**TOWN OF LOS GATOS  
CONCEPTUAL DEVELOPMENT ADVISORY COMMITTEE  
FEBRUARY 12, 2025  
110 EAST MAIN STREET  
TOWN COUNCIL CHAMBERS  
4:00 PM**

2. Consider a Request for Preliminary Review of a Proposal for Subdivision of One Lot into Three Lots on Property Zoned HR-2½. **Located at 401 Surmont Drive.** APN 527-20-002. Conceptual Development Advisory Committee Application CD-24-001. Property Owner: Srikanth Kasa. Applicant: Jason Chan. Project Planner: Ryan Safty.

SUBJECT: Consider a Request for Preliminary Review of a Proposal for Subdivision of One Lot into Three Lots on Property Zoned HR-2½. Located at 401 Surmont Drive. APN 527-20-002. Conceptual Development Advisory Committee Application CD-24-001. Property Owner: Srikanth Kasa. Applicant: Jason Chan. Project Planner: Ryan Safty.

TENTATIVE  
 FOR RUSSELL BATE  
**REVISED**

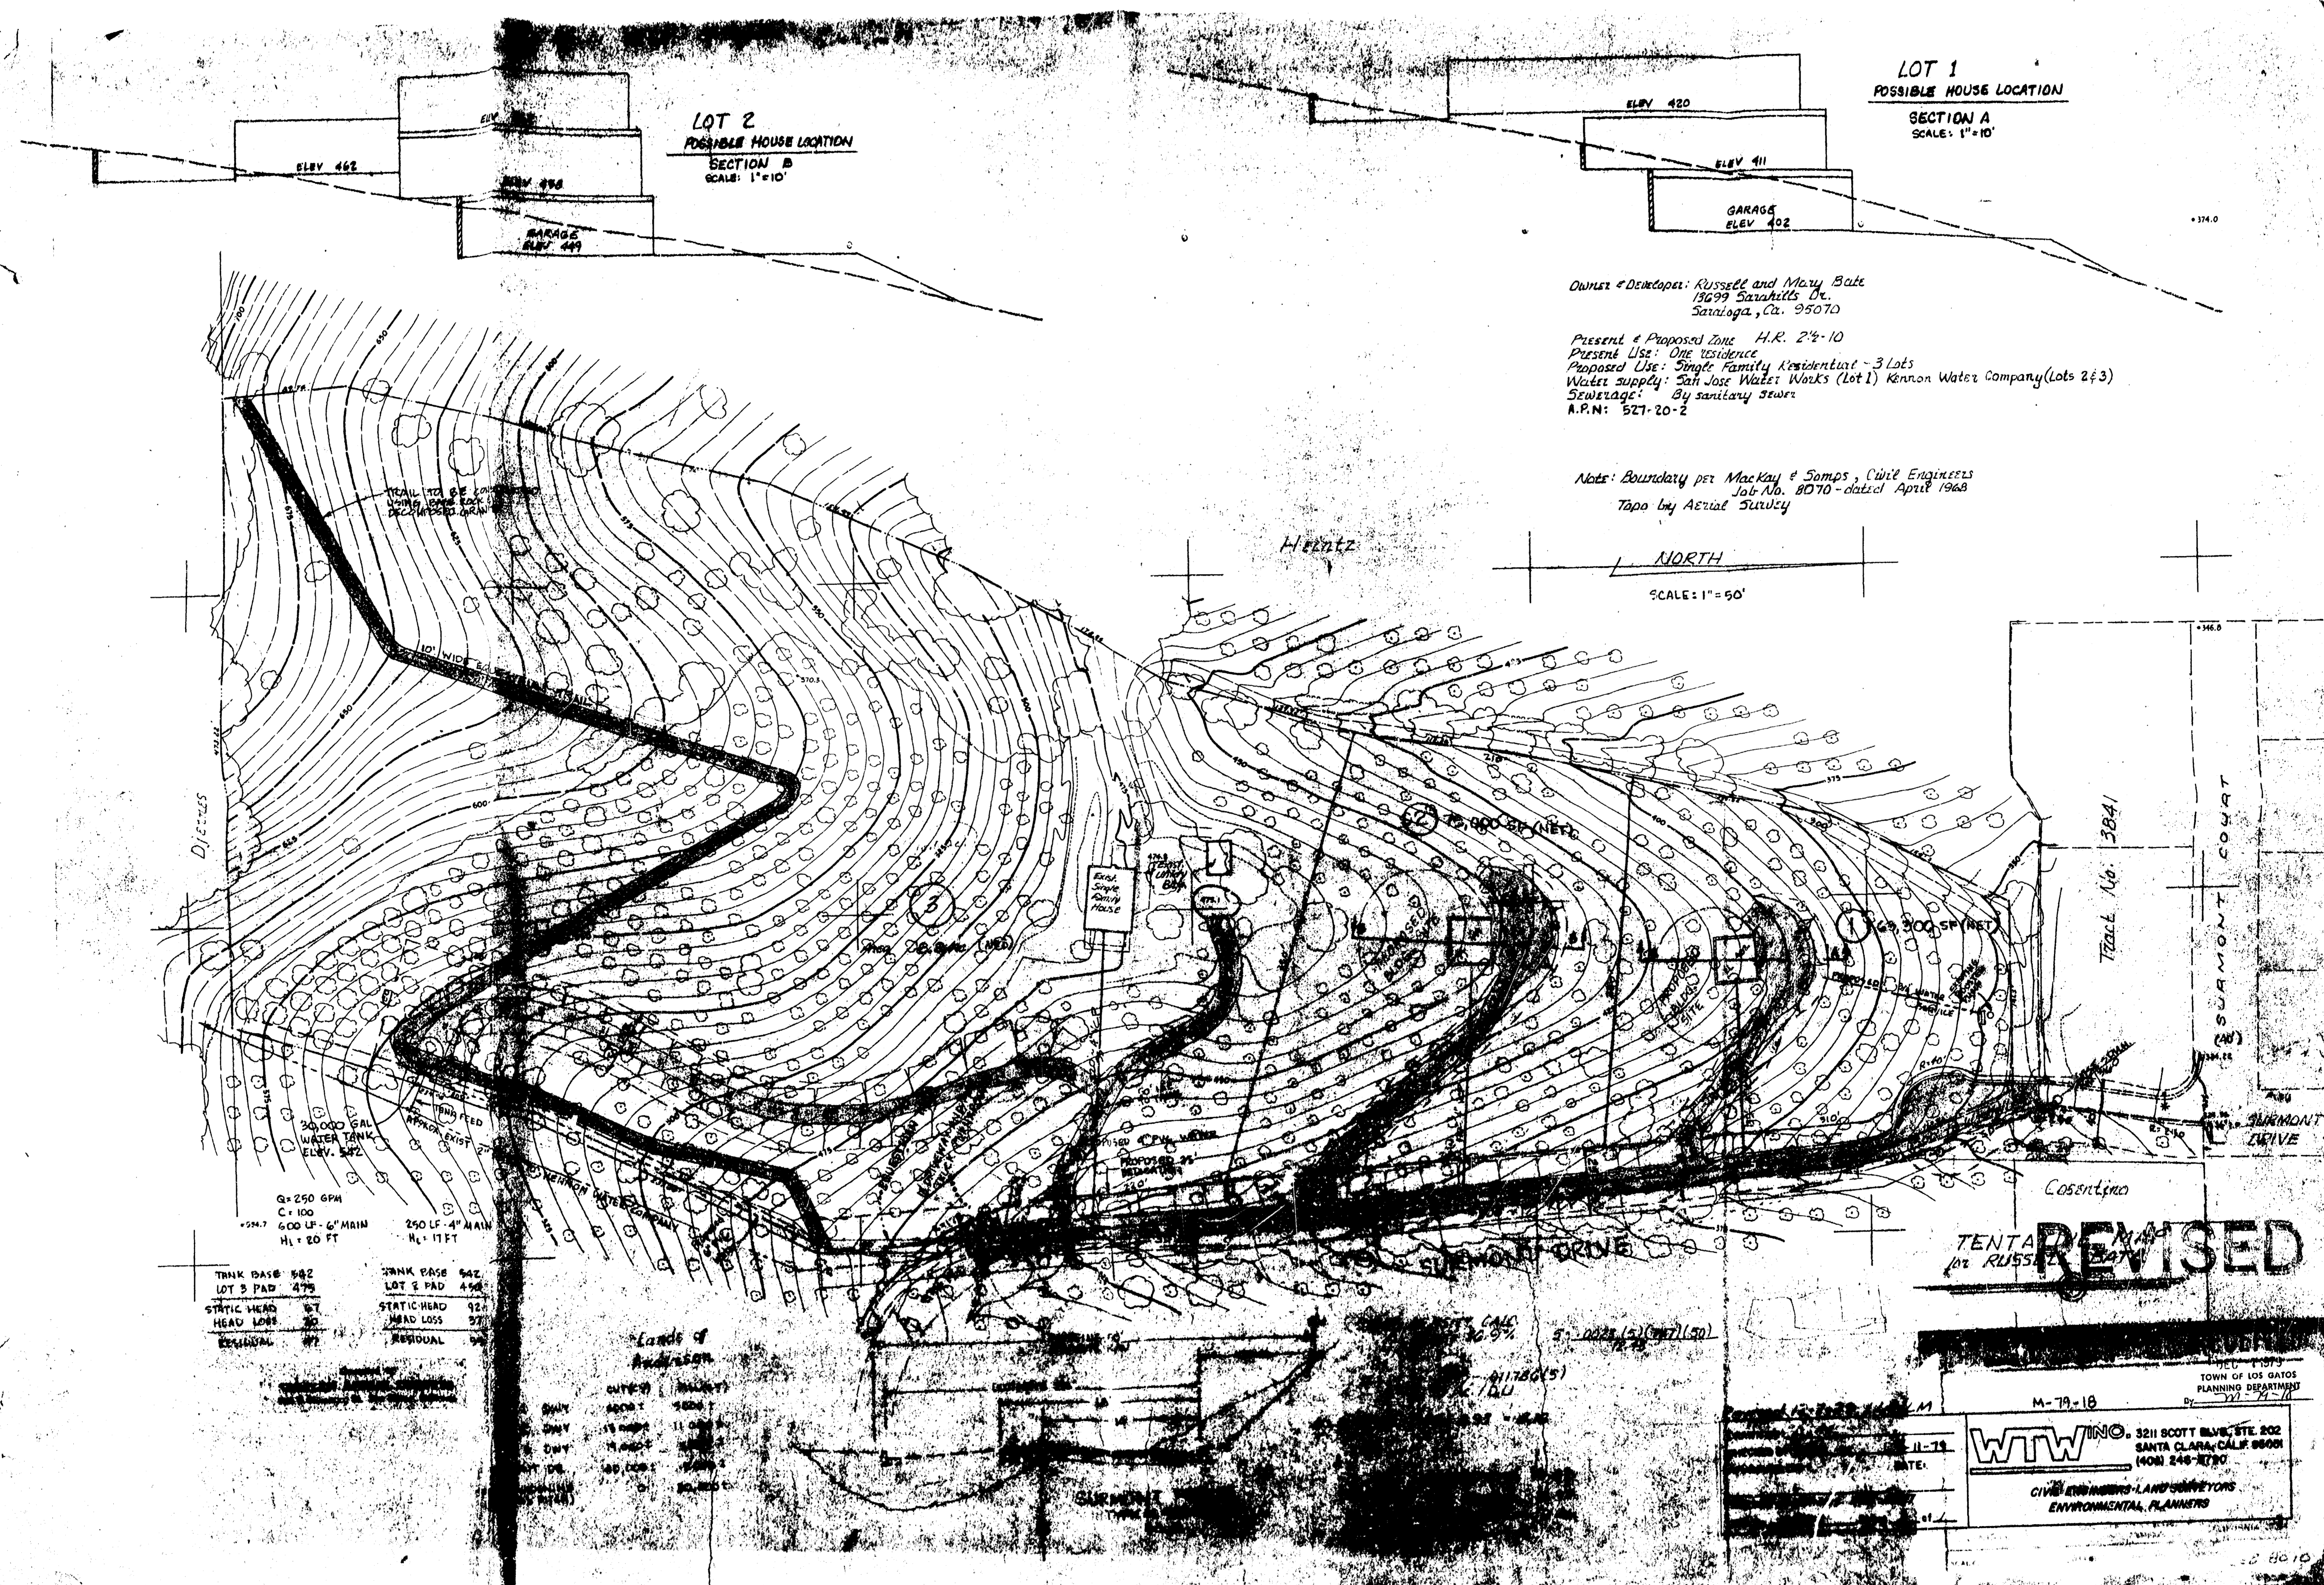
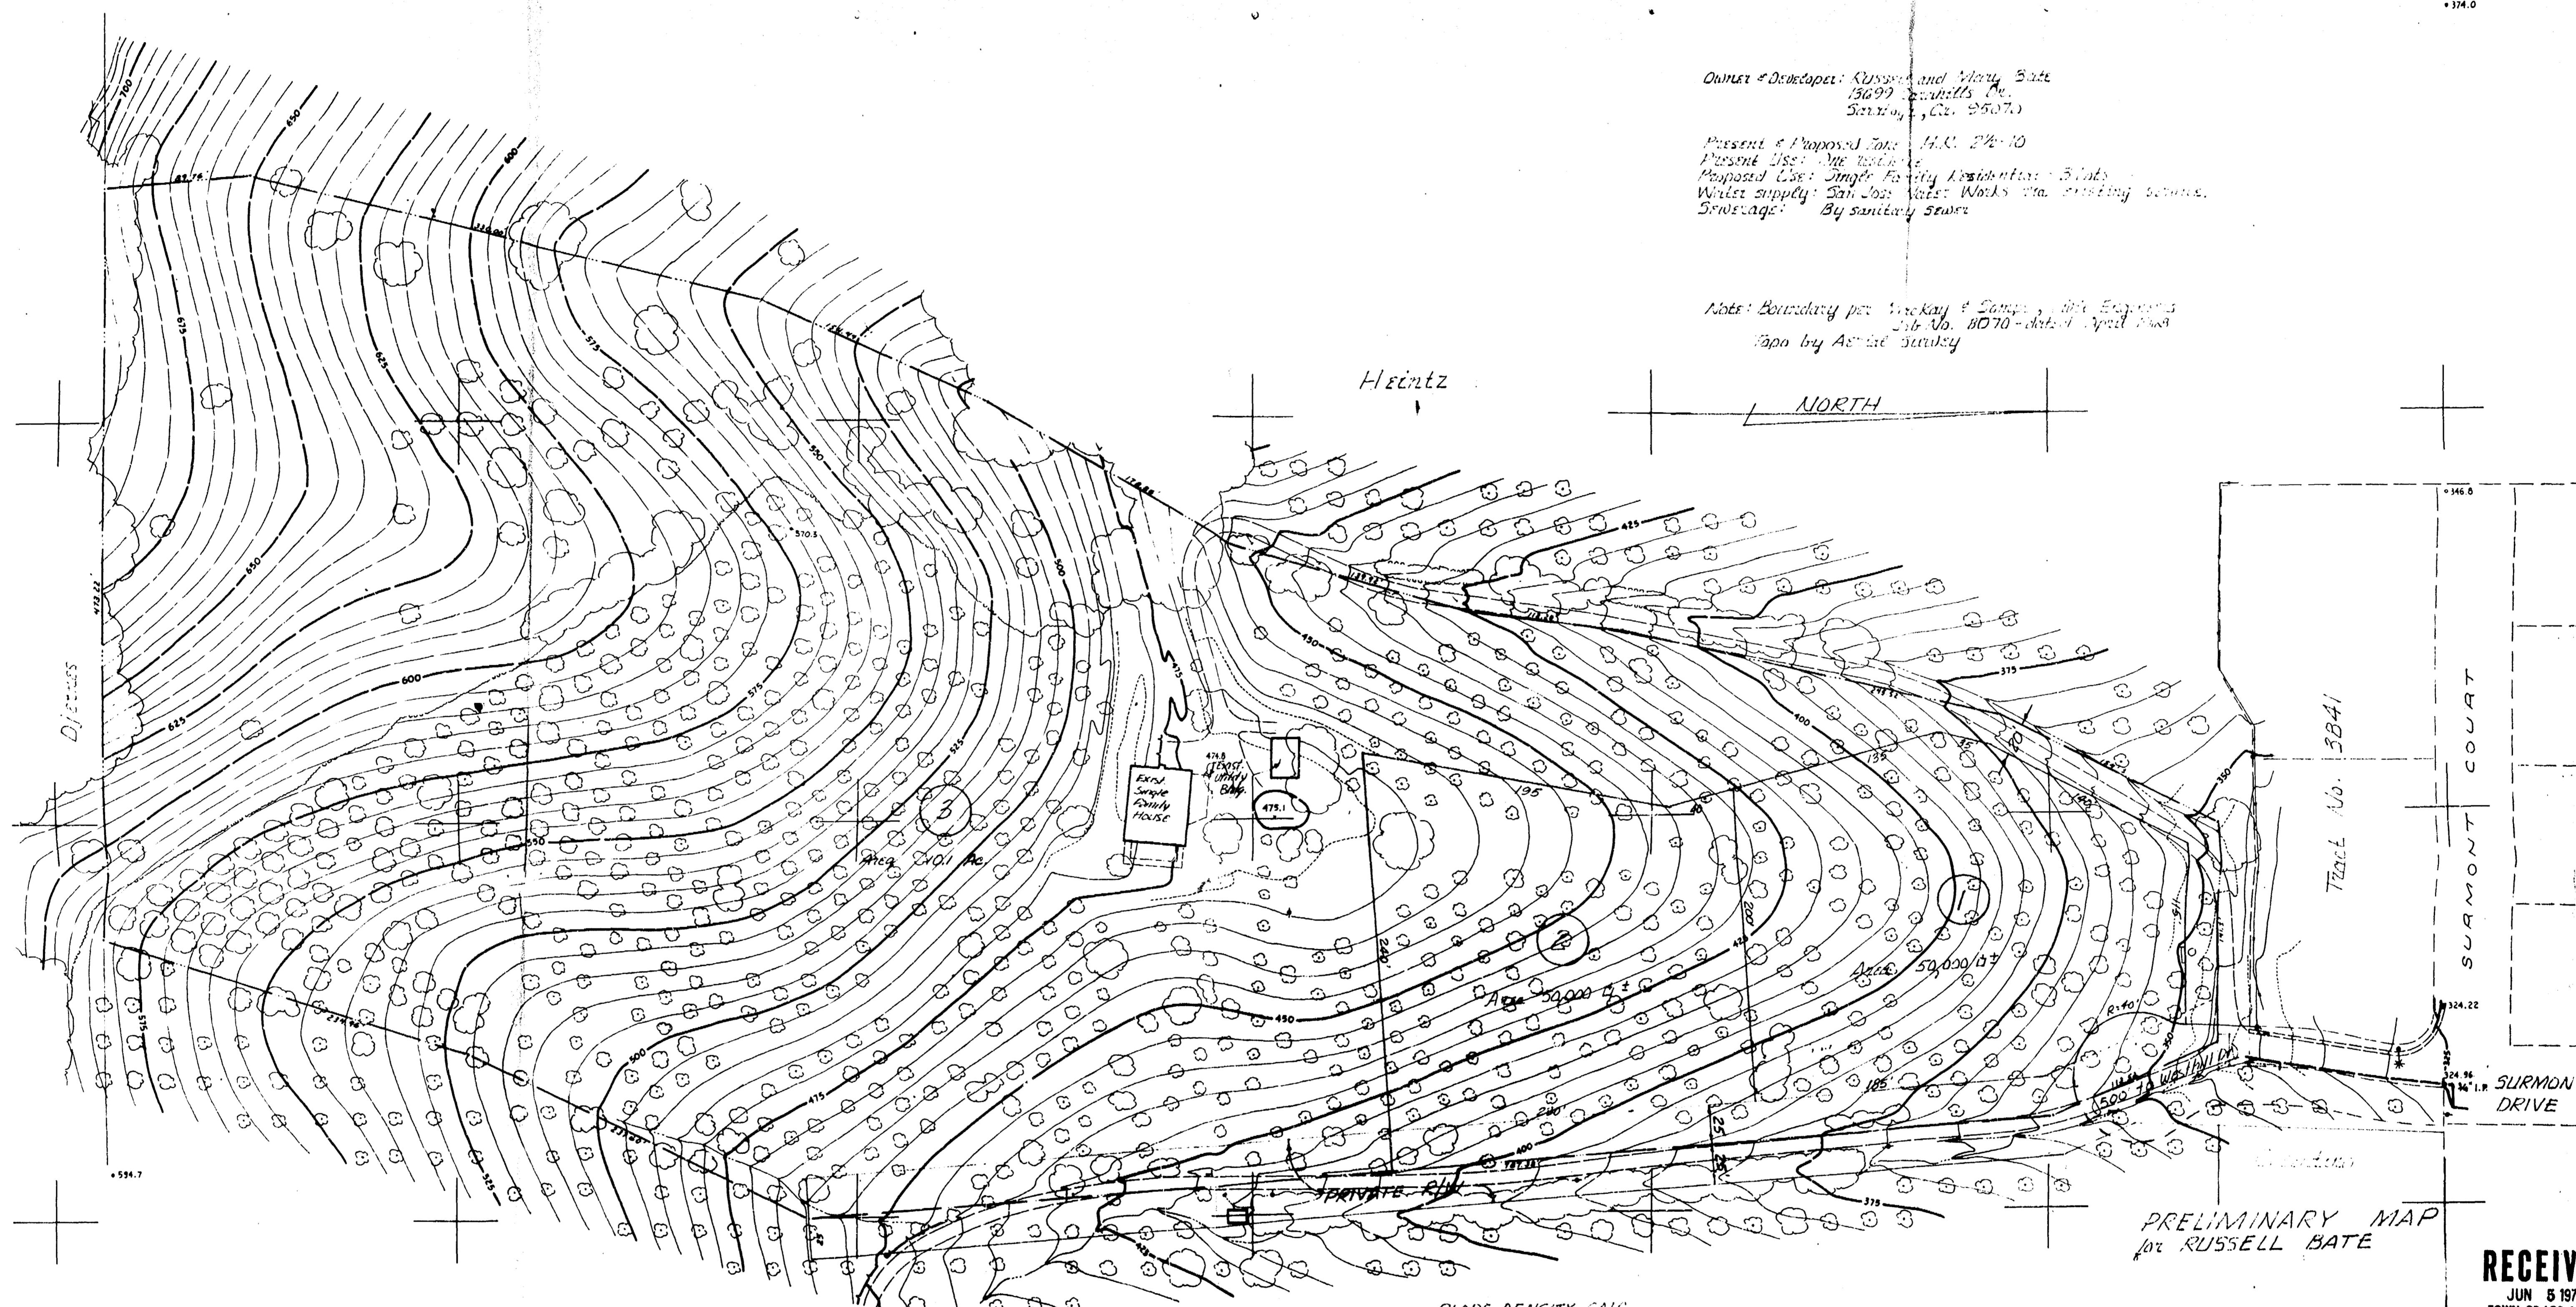
4. The grades of the driveways to the three lots are shown on the revised tentative map to be 15%. They will require substantial grading with up to 6-foot cuts indicated. The driveways are over 150 feet long, so will require one turnout each for emergency vehicles. The revised map shows fire truck turnarounds which will require extensive fill slopes (22 feet high for Lot #1 and 14 feet high for Lot #2).

5. The revised Tentative Map shows a concept plan for storm sewer installation of a 15-inch RCP on the roadway connected to an existing storm drain in Summit Drive.

6. The revised Tentative Map shows a concept plan for sanitary sewer with a 6-inch main proposed to be installed for the full length of the roadway. The laterals serving the three lots are also shown.

8. The revised map does not indicate how many trees will be required to be removed or what species the trees are.

The Development Review Committee recommends the Planning Commission deny Subdivision Application M-79-18, due to the inadequate water supply. However, should the Commission be in favor of this proposal, it must first be returned to the DRC in order to resolve the other deficiencies mentioned in this report before final approval may be granted.
